Appendix A - Item 20

PPL Bell Bend Nuclear Power Plant
Salem Township, Luzerne County, PA

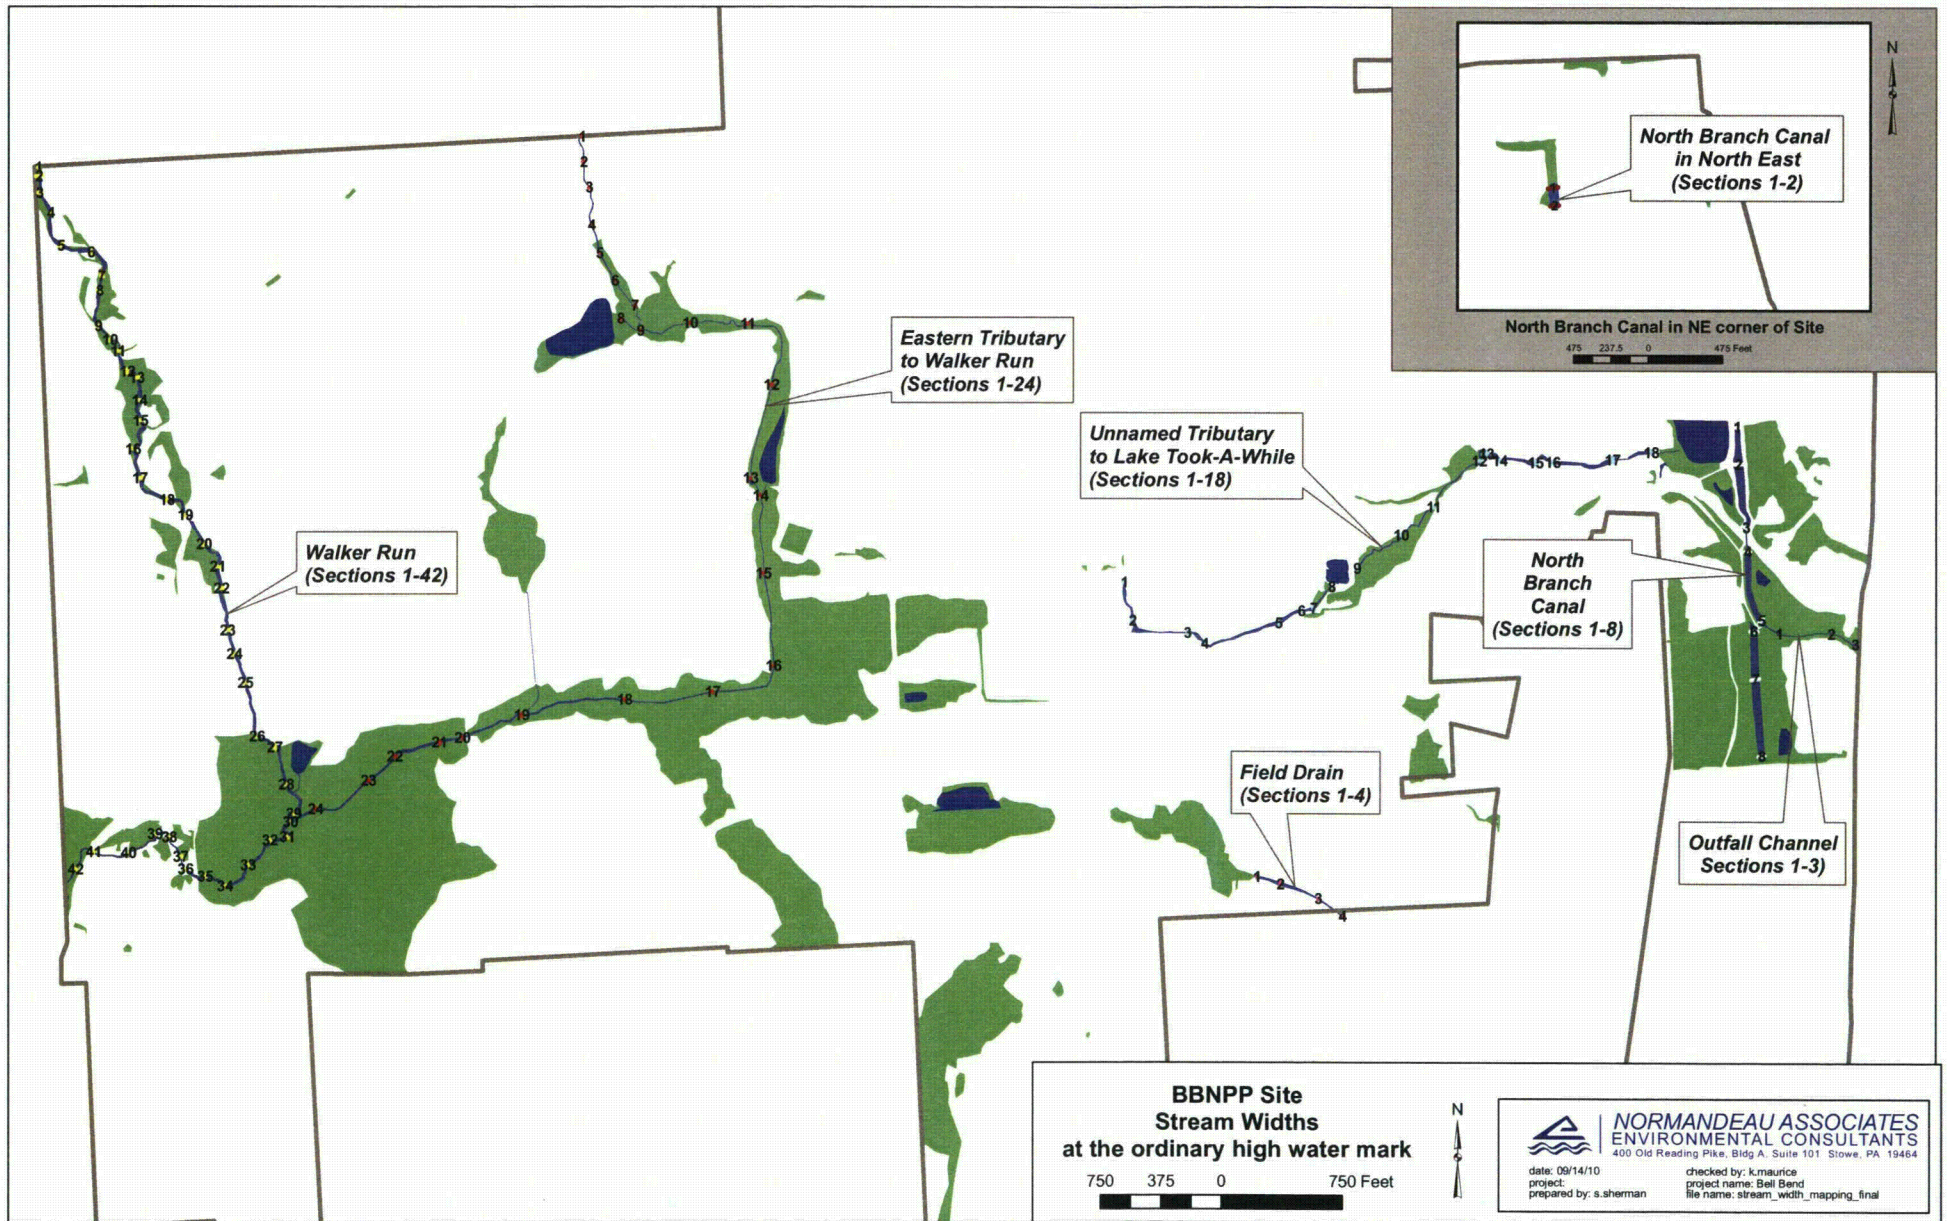
"Indicate the length and average width at the approximate ordinary high water mark of each stream proposed to be impacted. Indicate the total length and area of the stream to be impacted. Indicate the latitude and longitude coordinates of each stream proposed to be impacted at the upstream and downstream proposed impact limits, describe the condition of the stream in the proposed impact area."

See attached map and table for the length and average width at the approximate ordinary high water mark of each stream with proposed impacts.
